Supplemental Draft Environmental
Impact Statement for Ball Hill Wind Project

AUGUST 13, 2019

PREPARED FOR:
Villanova Town Board
1094 Butcher Road
South Dayton, NY 14138

OFFERED BY:
Ball Hill Wind Energy, LLC
11101 W. 120th Ave., Suite 400
Broomfield, CO 80021

Figure 1.1.1-2

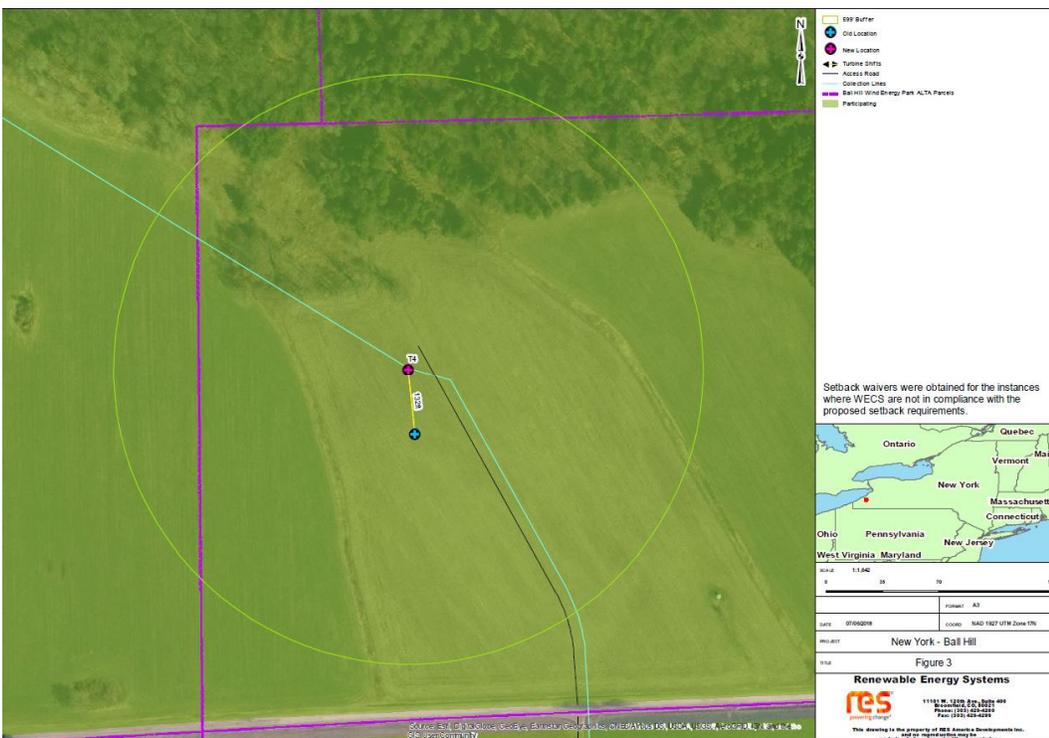
FACILITY	MODIFICATIONS AND RATIONALE
Turbine 2	Turbine moved ±129' to comply with larger setback
Turbine 4	Turbine moved ±132' to comply with larger setback
Turbine 8	Turbine moved ±128' to comply with larger setback
Collection Substation	Eliminated; reduce noise and light impacts
5.7-mile Overhead Transmission Line	Eliminated; replaced with four +/- 5.0 mile predominantly underground circuits to avoid and/or reduce wetlands, tree clearing and visual impacts.

Figure 2.2.1.3-1 FEMA Flood Zones

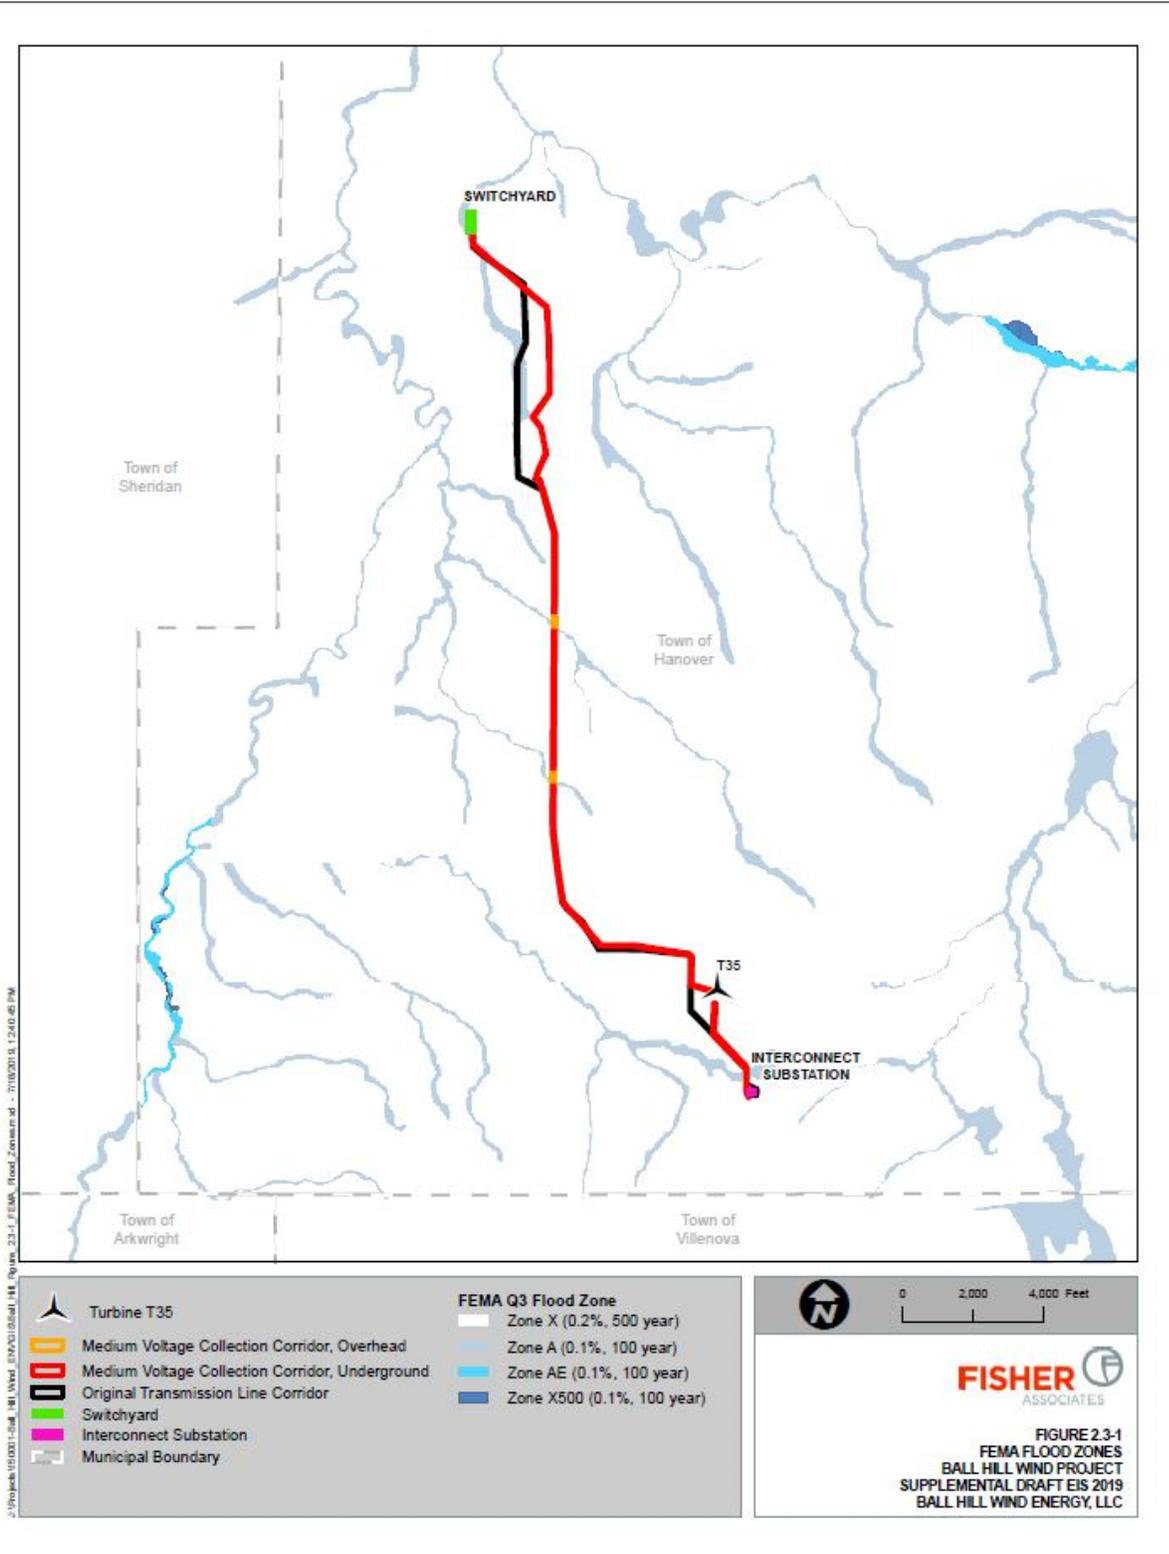
Figure 2.2.1.3-1 shows that both the original overhead electric transmission line and collection substation and the Underground Gentie corridor are located outside the 500-year floodplain (Zone X). However, there are areas of both corridors that lie within the 100-year floodplain (Zone A), although the change to the Underground Gentie corridor has reduced the amount of acreage that lies within the 100-year floodplain. This

Figure 2.2.1.3-2 Streams Delineated Along Underground Gentie Corridor

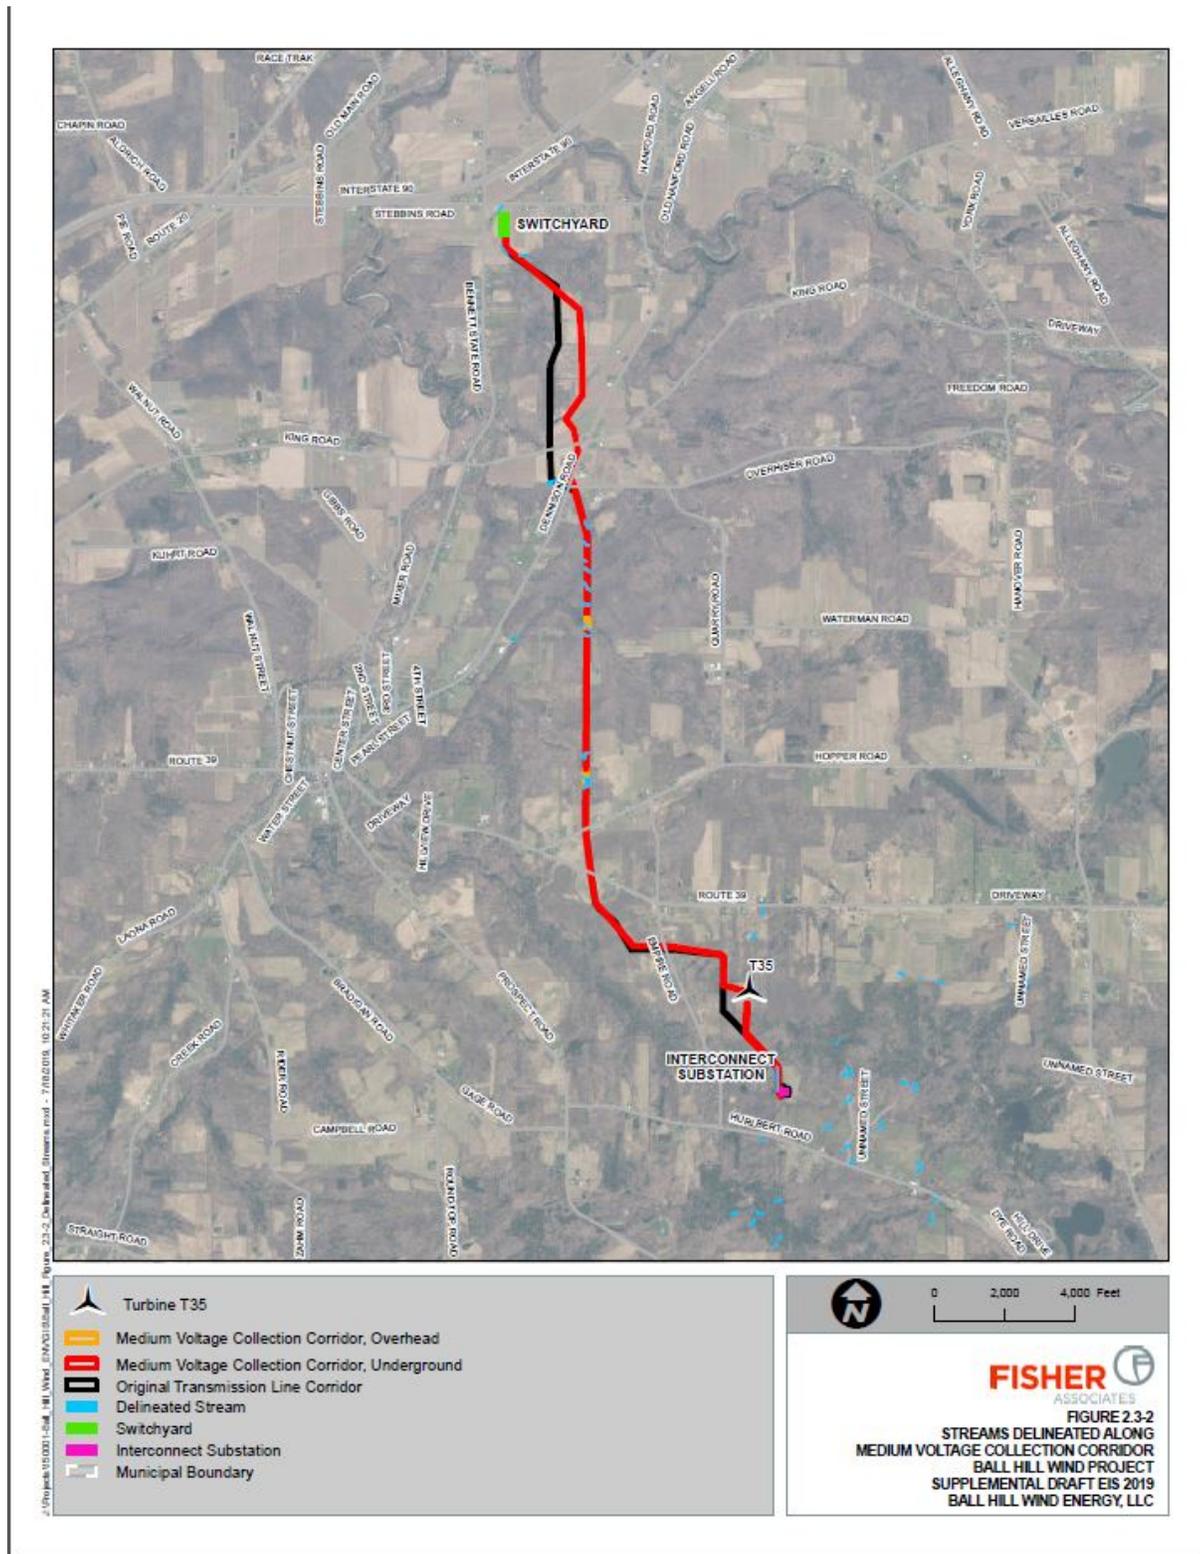
Additionally, streams were delineated within the Project Study Limits identified for the Proposed Action and are reported in the Revised May 2017 Ball Hill Wind Project Wetland Delineation Report and the June 2018 Ball Hill Wind Project-Supplemental Wetland Delineation Memo (see Appendix H). The potential sources of impacts on these streams are summarized in Table 7 and shown on Figure 2.2.1.3-2 below. Measures were taken during the Project's siting process to avoid stream crossings, such as the re-alignment and shift of the underground corridor along Dennison Road to avoid some large riverine (stream) channels. Overall, a total of 12 different stream crossings (four (4) perennial, two (2) intermittent, and six (6) ephemeral) were delineated along the original overhead electric transmission line and collection substation, whereas the Underground Gentie corridor has a total of 11 stream crossings (two (2) perennial, two (2) intermittent, and seven (7) ephemeral). Additionally, the temporary impacts to all streams has decreased from 1,492 linear feet to 1,175 linear feet (733 linear feet underground collection, and 442 linear feet of overhead collection) due to the realignment of the collection corridor, and the removal of the substation. Since there are no permanent buildings and roads proposed within the Underground Gentie corridor there will be no permanent impacts to streams. Additionally, there will be no permanent impacts to streams since the pole structures and guy wires that are necessary for the 0.2 miles of remaining overhead collection line will be located outside of stream channels.

Figure 2.2.1.4-1 Delineated Wetlands Along Underground Gentie Corridor

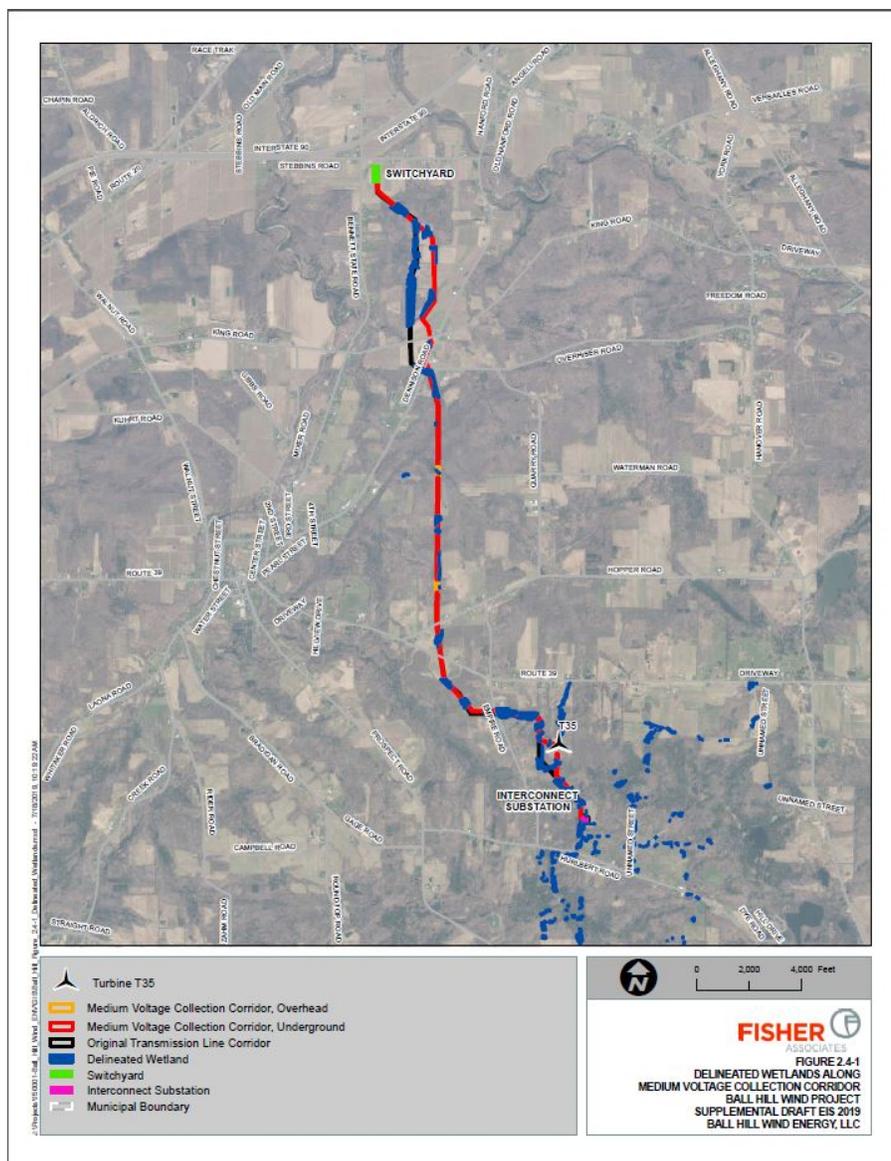
6.20 acres of permanent PFO wetland conversion. Wetland impacts resulting from the proposed Underground Gentie corridor are reduced to 8.01 acres (7.93 acres for underground and 0.07 acres for overhead) of temporary wetland disturbance and 3.74 acres (3.67 acres for underground and 0.07 acres for overhead) of permanent PFO wetland conversion. Specifically, this decrease is due to the elimination of a portion of the ROW southwest of Turbine 35, the realignment of a portion of the ROW between Dennison Road and where the Interconnection Substation was previously located, and the planned directional bore under the delineated PFO wetlands that are part of the NYSDEC Freshwater Wetland SC-12 and SC-13 complexes.

It is important to note that the remaining 8.01 acres (7.93 acres underground and 0.07 acres overhead) of unavoidable disturbance to wetlands will be temporary. This is because these are emergent or scrub-shrub wetlands that will be restored back to the original pre-construction conditions and vegetation will be reestablished and allowed to re-generate.
